## MAGNOLIA BRANCH ESTATES SUBDIVISION

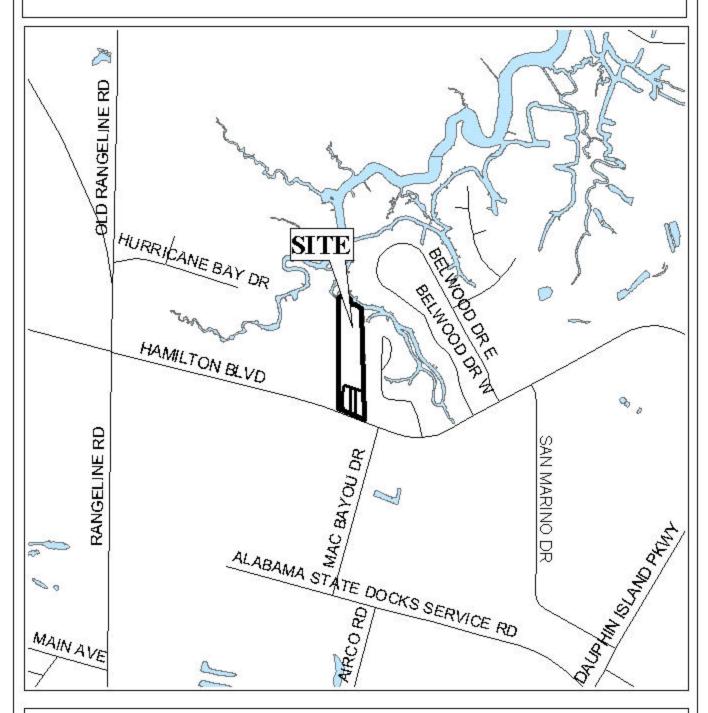
The site fronts Hamilton Boulevard, a planned major street, which has an existing right-of-way shown as 80 feet; the Major Street Plan requires a 100-foot right-of-way. Therefore, the dedication from the centerline of Hamilton Boulevard, to provide for the right-of-way of the planned major street, should be required. Additionally, as a means of access management, the placement of a note on the final plat stating that Lots 1, 2 and 3 are limited to one curb cut each to Hamilton Boulevard, with the size, location and design to be approved by County Engineering, should be required.

## DETAIL SITE PLAN

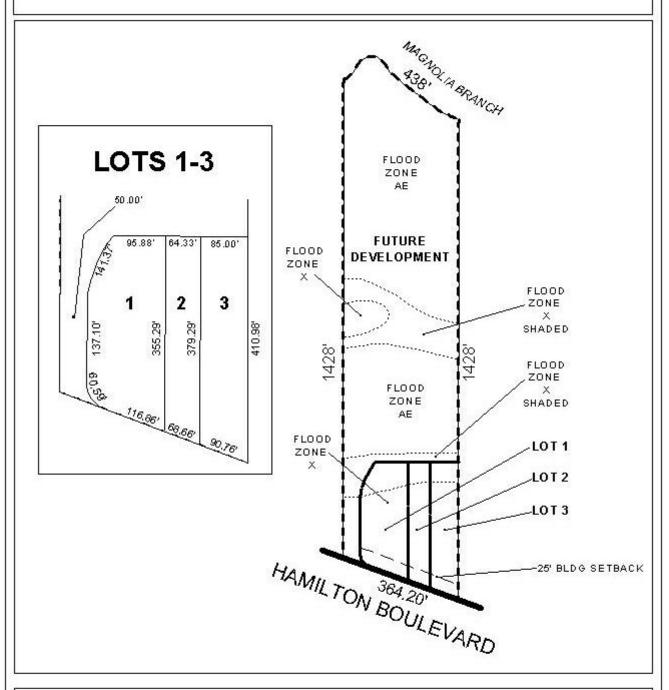
As proposed, Lots 2 and 3 would exceed the width to depth ratio, therefore a waiver of Section V.D.3. would be required. It should be noted that the waiver is recommended due to the flood zones located on the site.

As indicated on the Detail Map, the site is located in the 100-year floodplain and as such the area may be considered environmentally sensitive; therefore, the approval of any necessary federal, state and local agencies would be required.

With a waiver of Section V.D.3., the proposed plat meets the minimum requirements of the Subdivision Regulations and is recommended for Tentative Approval subject to the following conditions: 1) the dedication of sufficient right-of-way from the centerline of Hamilton Boulevard; 2) the placement of a note on the final plat stating that Lots 1, 2 and 3 are limited to one curb cut each to Hamilton Boulevard, with the size, location and design to be approved by County Engineering; 3) the developer to obtain the necessary approvals from federal, state and local agencies prior to the issuance of any permits; and 4) the placement of a note on the final plat stating that any lots which are developed commercially and adjoin residentially developed property must provide a buffer, in compliance with Section V.A.7. of the Subdivision Regulations.
